Regulations 49 and 83 – LPG reference fuel

Document GFV-02-2

Expert from Poland

56 GRPE

Proposed amendments:

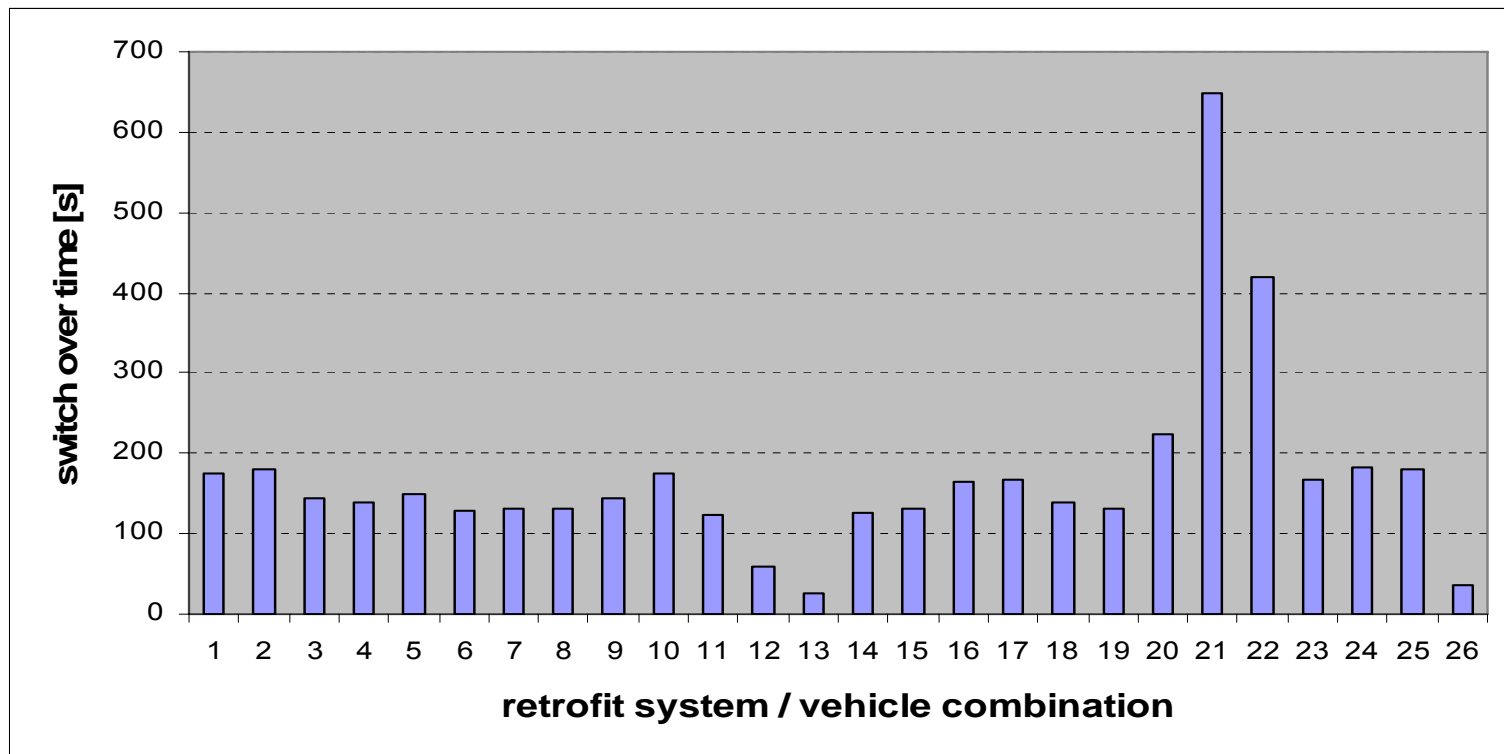
e). The introduction of the “non-intrusive” concept leads to the situation that the emission limit values for the “intrusive” and “non-intrusive” systems are different which should not be acceptable.

Consequently, the limit values are not performance-oriented, but are design-oriented.

- (i) The following paragraphs should be deleted:
 - 2.1.5,
 - 3.2.5,
 - 5.2,
 - 6.1.2.2,
 - 6.1.2.5.1.4,
 - 6.1.2.5.1.4.1,
 - 6.1.2.5.1.4.2,
 - 6.1.2.5.3.4,
 - 6.1.3.4,
 - Annex 1A, item 11.1, the second line,
 - Annex 3A, item 2.4.
- (ii) Paragraph 6.1.2.5.1.2 should be amended.
- (iii) Paragraph 6.1.3.1 should be amended.

The switch over time of some retrofit system/vehicle combinations submitted for the type-approval in Poland is shown below

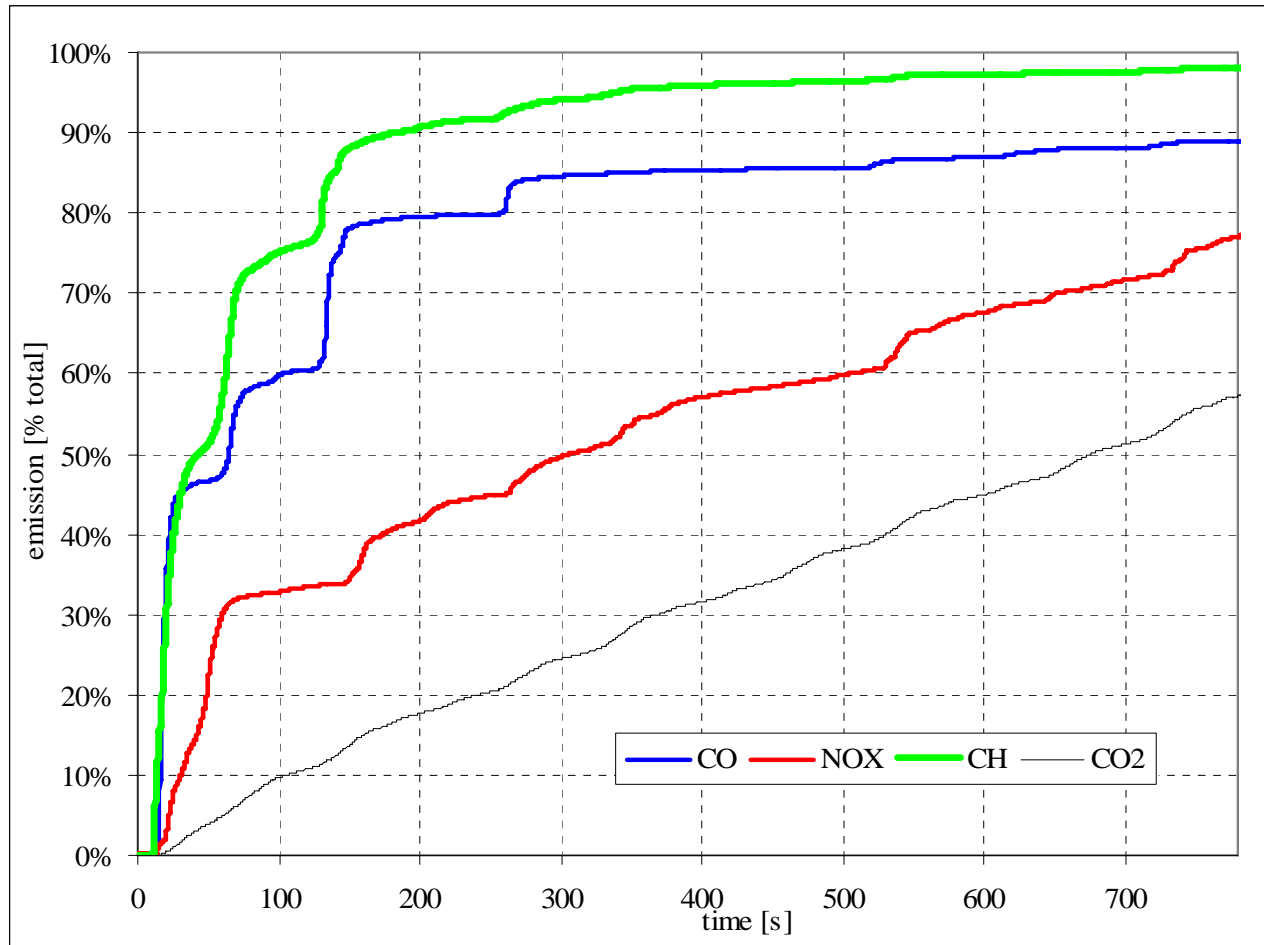
In Figure above the switch over time varies from 25 s (the shortest time found) to 648 s (the longest time found). If:

- the ratio of the actual emission with petrol to the limit value is 40 %,
- the switch over time is 648 s,
- and the relative emission versus time curve is similar to that shown above,

the emission with LPG may be even 70 times higher than that with petrol and the vehicle is deemed to comply with the requirements of Regulation 115 for “non-intrusive” retrofit systems. Even when the switch over time is 25 s, the emission with LPG may be 3 times higher.

Relative emission versus time for vehicle B (Euro 3) in the urban part of the type 1 test (Source: Environmental Protection Centre, Motor Transport Institute, Warsaw, Poland)

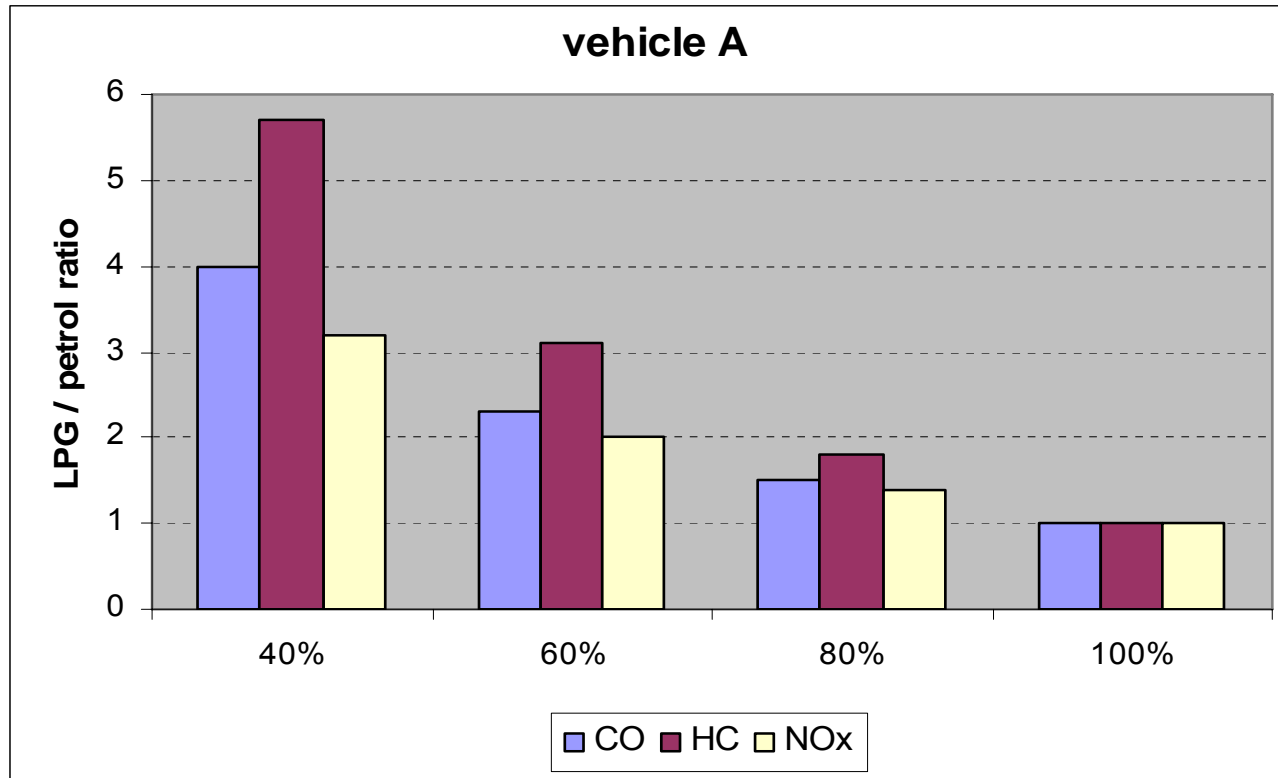
The ratio of the emission with LPG in LPG mode divided by the emission with petrol in petrol mode in the period equivalent to the operation with LPG in LPG mode (referred to as “LPG/petrol emission ratio” hereinafter) is calculated for each pollutant for “non-intrusive” retrofit systems installed in vehicles A and B. The following assumptions are applied:

- (a) The retrofit system is truly, not apparently, “non-intrusive”, i.e. the emission with petrol before the retrofit is identical to that with petrol in LPG mode or in petrol mode after the retrofit.
- (b) The switch over time is equal to 60 s. This time is selected because the EU draft comitology Regulation for LDV specifies that “During the type 1 test the vehicle shall use only petrol for a maximum of 60 s when operating in gas mode”.
- (c) The ratio of the emission with petrol measured over the type 1 test to the emission limit is equal to 40%, 60%, 80%, 100%
- (d) The total emission in the type 1 test in LPG mode is equal to the limit.

LPG/petrol emission ratio for different ratio of actual emission with petrol to limit (40%, 60% 80%, 100%) for “non-intrusive” retrofit system

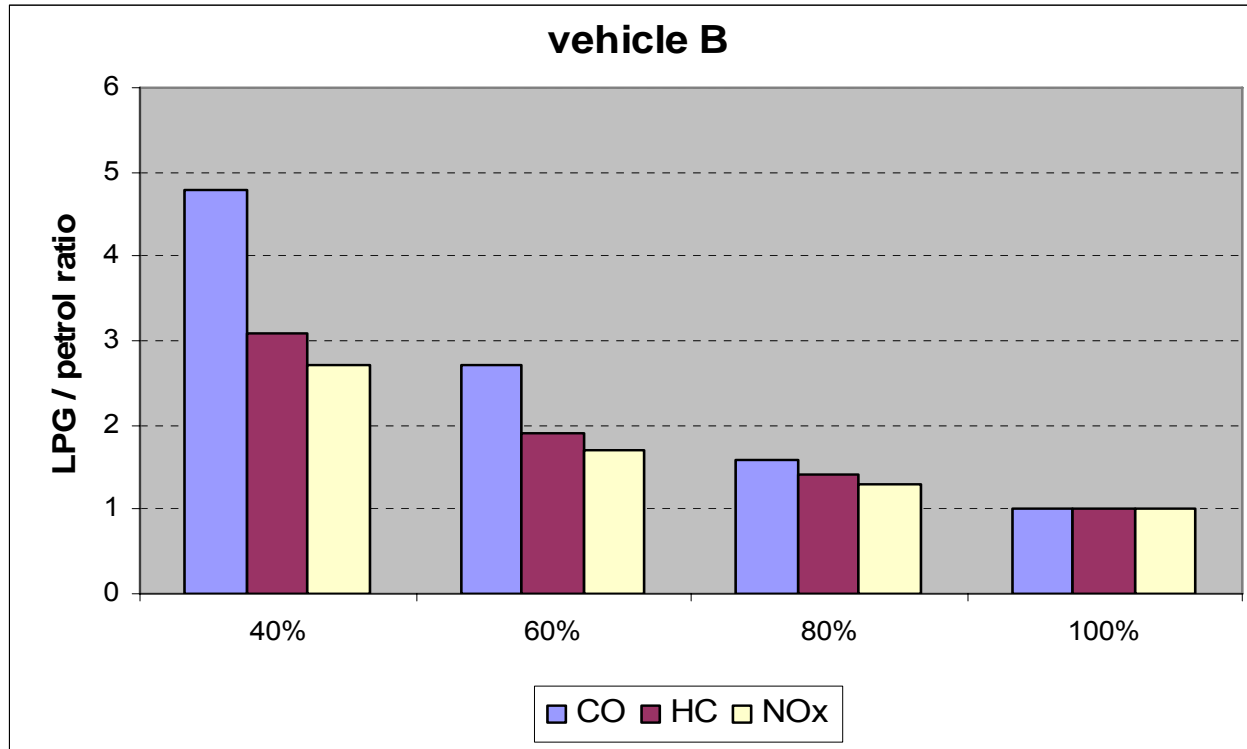
The ratio of the actual emission with petrol to the limit value is usually in the order of 40% - 60% for Euro 3 and Euro 4 vehicles. If:

- it is equal to 40%,
- the relative emission versus time curve is similar to those shown above,
- and the switch over time is 60 s,

the emission with LPG may be even about 5 times higher than that with petrol and the vehicle is deemed to comply with the requirements of Regulation 115 for “non-intrusive” retrofit systems.
